UNITED STATES PATENT AND TRADEMARK OFFICE

APPLICATION NO.	FILING DATE	FIRST NAMED INVENTOR	ATTORNEY DOCKET NO.	CONFIRMATION NO.
10/784,544	02/23/2004	George Athanasios Aggidis	04-40092-US	7766
7066	7590	03/13/2006	EXAMINER	
REED SMITH LLP 2500 ONE LIBERTY PLACE 1650 MARKET STREET PHILADELPHIA, PA 19103			EDGAR, RICHARD A	
			ART UNIT	PAPER NUMBER
			3745

Office Action Summary

DETAILED ACTION

Figure 1

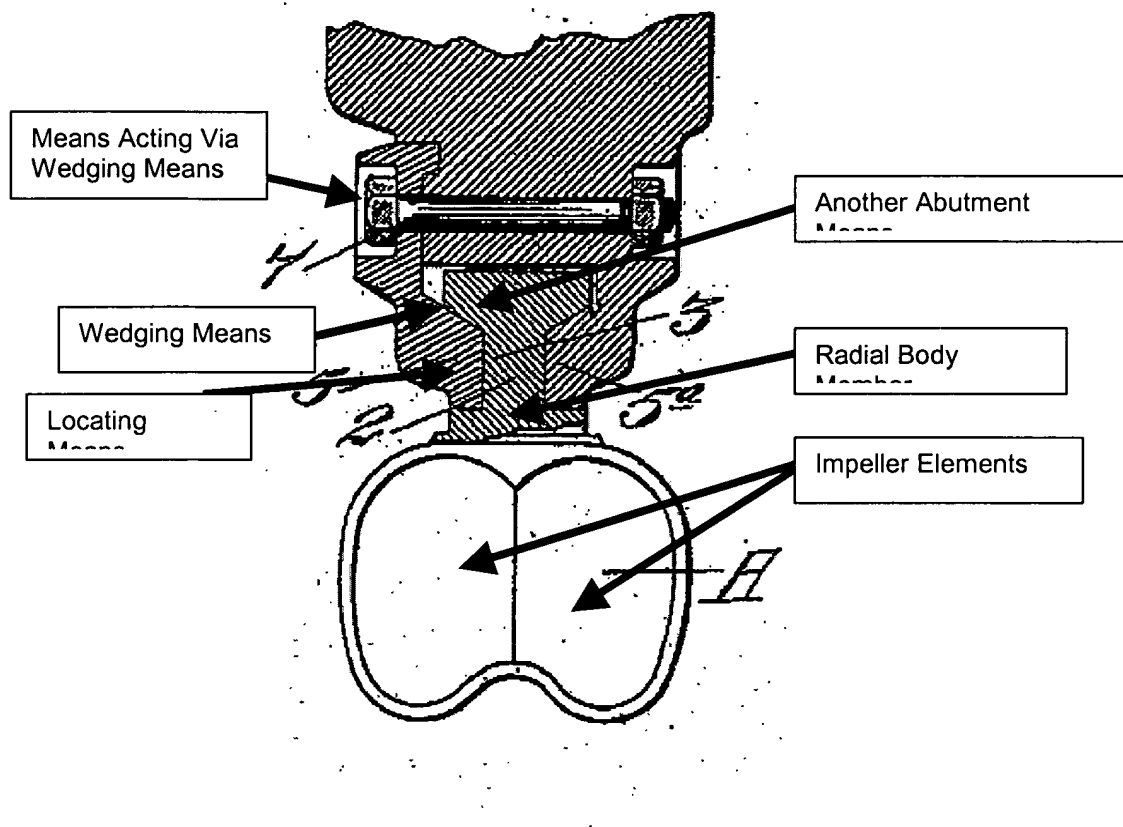
Eckart shows a turbine rotor having an axis of rotation, the wheel inherently mounted on an axle, a plurality of individual radial body members (see FIG. 3) carrying more than one integral impeller elements, and wherein the plurality of radial body members are secured to the wheel; each radial body member having leading and trailing radial abutment surfaces (see FIG. 2) relative to the rotation direction of the rotor that contact with the respective radial abutment surfaces of adjacent radial body members, each radial body member further comprising another abutment means (see FIG. 4), the turbine rotor further comprising locating means in engagement with the another abutment means, and wedging means which is tapered in the radial direction relative to the rotation axis and which acts between the abutment means and the locating means, and further comprising means acting via said wedging means to draw the radial body members radially inwards resisted only by contact of the respective adjacent leading and trailing radial abutment surfaces of the body members. See Figure 1 below.
